**SERVICE INFORMATION**

Bulletin Nbr: 771-2254

**Adaptation of wheel housing to 17" wheels**

Saab 9-3 CV model year 2000 with engine type B205R (200 hp).

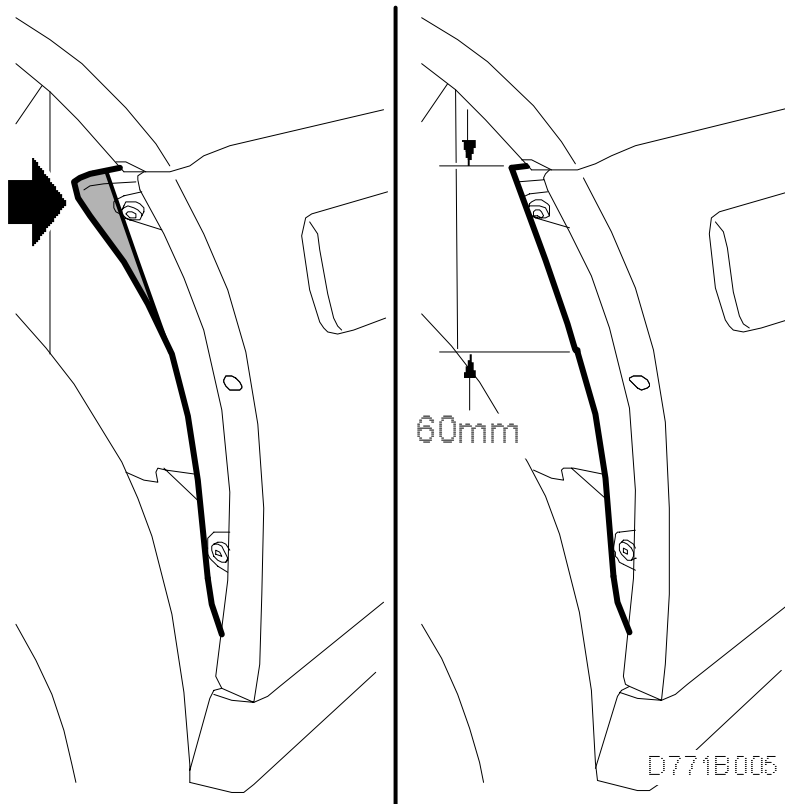
Upon maximum compression on the springs, when carrying heavy cargo for example, the wheels will scrape against two plastic nuts in the front wheel housing and a plastic corner on the rear bumper.

1. Grind or file off the corner of the rear bumper from the top edge down 60 mm. Grind the top end in to the rivet.

Be careful not to grind so much that the plate within the plastic is damaged.

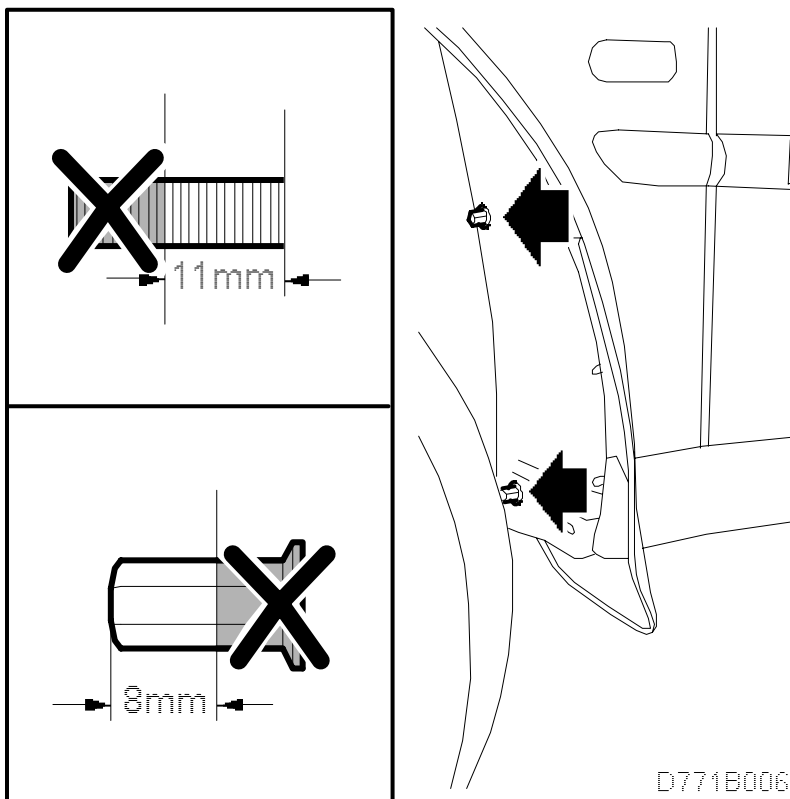
2. Remove the plastic nuts from the two lower bolts in the wheel housing behind the front wheel.

3. Cut the bolts to a max. length of 11 mm, measured from the metal of the body.
4. Grind the nuts to a length of 8 mm.

5. Refit the nuts.
